Re: Public Comments on the Sitewide Remedial Investigation Report ("RIR") Addendum for the Philadelphia Energy Solutions Refining & Marketing ("PES") Site; 3144 Passyunk Avenue, Philadelphia, PA, EPA RCRA Corrective ID PAD049791098

> Sitewide Remedial Investigation Report Addendum Stantec Consulting Services Inc. May 20, 2022

> > Former Philadelphia Refinery 3144 Passyunk Avenue Philadelphia, Pennsylvania Sitewide PADEP Facility ID No. 780190

Written Comments by Clean Air Council

See Proposed Addendum, Figure 13 (page 677 of 1435 in the pdf document)

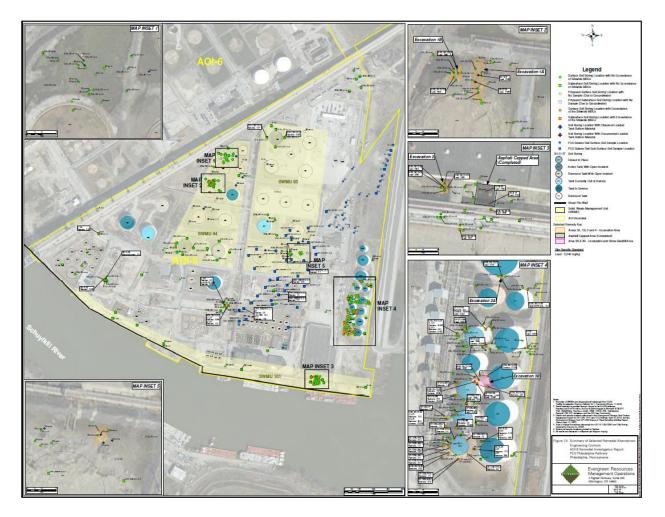
See Proposed Addendum, page 7 (emphasis added). This assertion is erroneous because Evergreen has failed to identify a large number of lead exceedances, even outside AOI-9.

The Council will use AOI-5 as an example of how Evergreen has not identified many lead samples exceeding 1000 mg/kg.

In the following Figure in the Proposed Addendum, Evergreen highlights exceedances of the direct contact numeric value of 1000 mg/kg for lead with orange circles:

With respect to the AOI-5 remedial investigation report in 2017, the Council has counted more than 50 lead samples with concentrations above 1000 mg/kg. *See* AOI-5 Report, part 1 (January 16, 2017), Table 4, <u>https://phillyrefinerycleanup.info/wp-content/uploads/2019/02/Philadelphia-Refinery_AOI-5-RIR_01-16-17_Part1.pdf</u>; *see also* Attachment 1 – AOI-5 Lead samples in excess of NRDC, soil-to-groundwater numeric value, or groundwater MSC (compiled by Clean Air Council). Evergreen's map in the Proposed Addendum shows only about half of these exceedances.

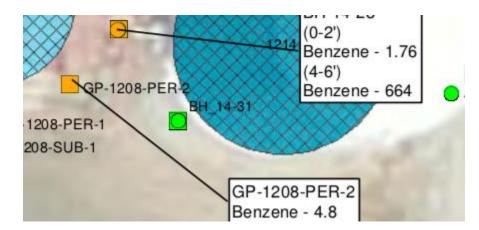
For example, Evergreen erroneously highlights sample AOI5_BH-13-33 in green (see below), indicating that it is below the direct contact numeric value:

See id. (magnified). The measurement taken on March 7, 2013 was 1090 mg/kg, which is an exceedance.

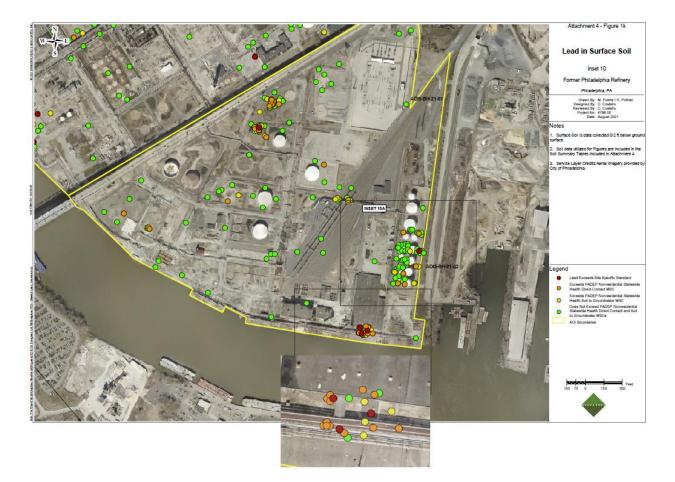
Similarly, Evergreen erroneously highlighted sample Bh_14-31 in green:

See id. (magnified). The measurement from June 19, 2014 was 1980 mg/kg.

The mischaracterization cannot be attributed to Evergreen's claim to (sometimes) delineate only samples "near the perimeter" of the site based on the 1000 mg/kg value, as discussed in section (d) below. For example, Sample Bh_14-31 is closer to the site boundary than other samples (e.g. GP-1209 SW) that are in the center of this specific site.

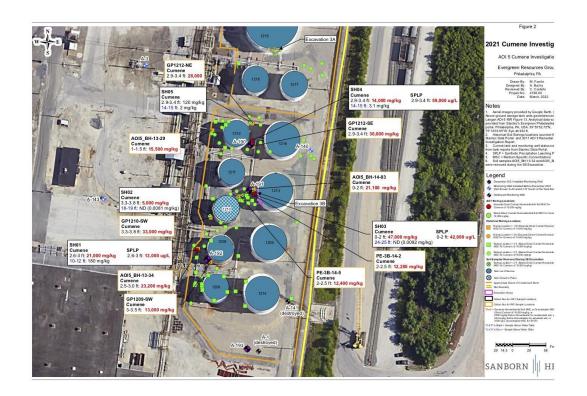
Evergreen has incorrectly delineated cumene in surface soil in AOI-5 using only the direct contact numeric value, and not using the soil-to-groundwater numeric value. As noted above, based on Section 250.305, the soil-to-groundwater numeric value applies if it is lower than the direct contact numeric value, and groundwater is within the buffer depth from the surface. Indeed, Evergreen claims to follow this regulatory requirement for all contaminants except lead. It made such a statement in its response to the Council's comments in the AOI-9 second remedial investigation report addendum dated November 29, 2021:

See Evergreen Response to Public Comments (Second Remedial Investigation Report Addendum) (November 29, 2021), page 14 (emphasis added), <u>https://phillyrefinerycleanup.info/wp-</u> <u>content/uploads/2021/11/AOI9_2nd_RIR_Addendum_PC_Response_11-29-2021.pdf</u>. As noted, the water table is high throughout much of AOI-5, making the soil-to-groundwater numeric value relevant to the investigation in this area.

Evergreen should revise its analysis to identify all cumene samples to which the soil-togroundwater numeric value (2,500 mg/kg) applies, revise the list of cumene exceedances to show all relevant instances where cumene was found at values above 2,500 mg/kg, and re-examine the need to delineate cumene contamination based on the revised list of contaminated locations.
